**Z-26
(2009)**

PETITION NO: Z-26

ZONING DIVISION COMMENTS:

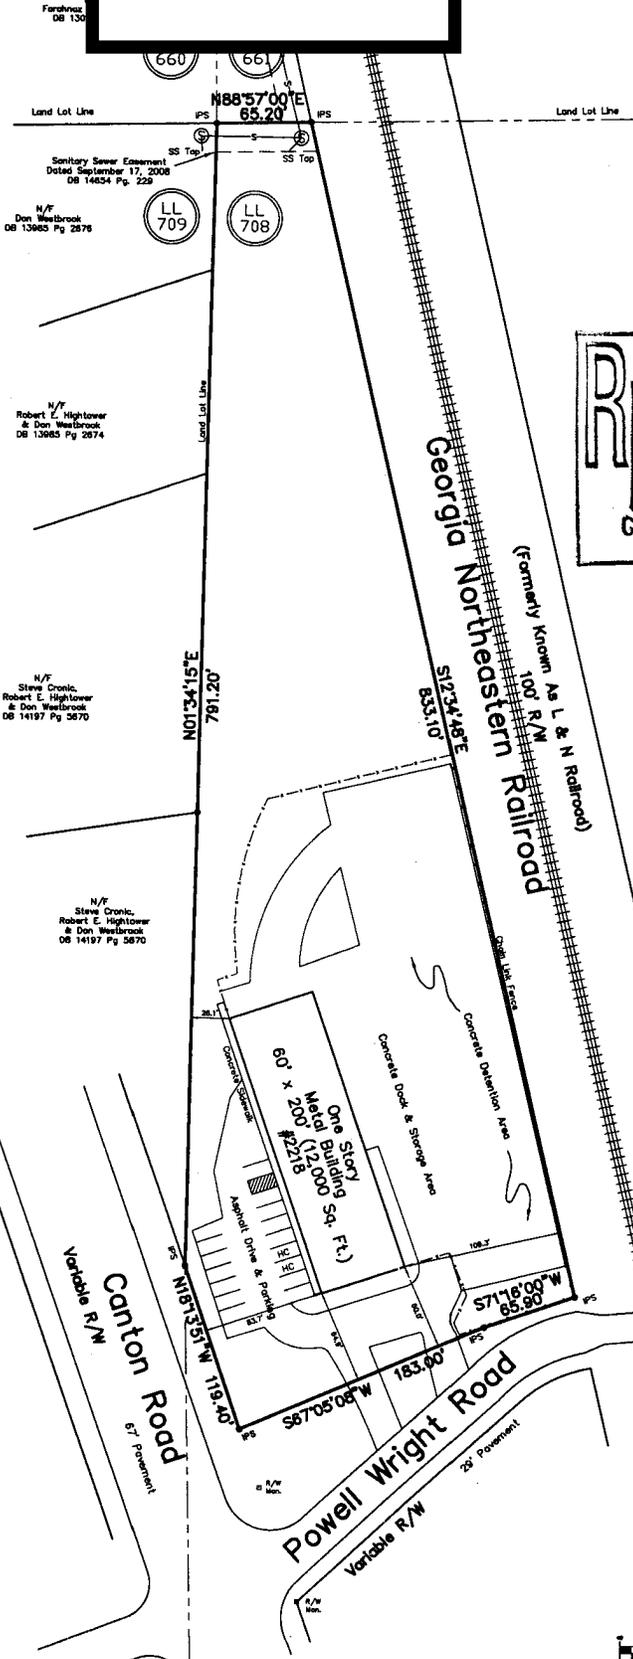
1. Although no improvements are currently proposed for this site, the existing detention pond located at the southeast corner of the site needs maintenance. There is a significant amount of debris and sediment in the pond that needs to be removed.
